**DECC Consultation on the second version of the Smart Metering
Equipment Technical Specifications**

**British Gas response
8th October 2012**

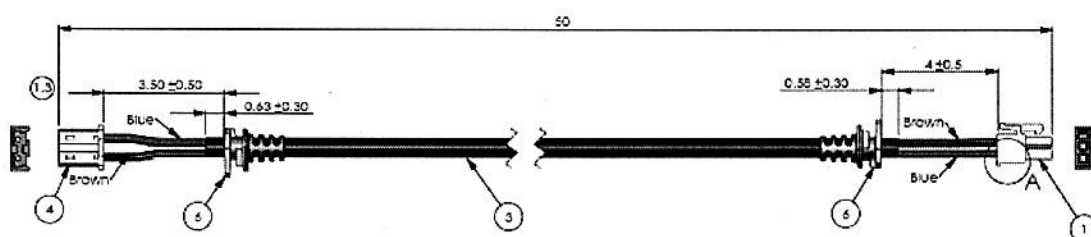
Question 13. Do you have views on the specification for an 'intimate' interface between electricity meters and communications hubs?

- 13.1. To facilitate an open, fair and competitive market, gas suppliers need the ability to install smart gas meters without being dependent on the actions of (and information from) an electricity competitor. DCUSA modifications are currently being progressed to allow gas suppliers to install a stand-alone communications hub that can support single-fuel gas and dual-fuel consumers. This uses the same principle as a stand-alone hub: the only modification is a mounting bracket, or 'hot-shoe', that allows a mains connection before the dumb electricity meter:
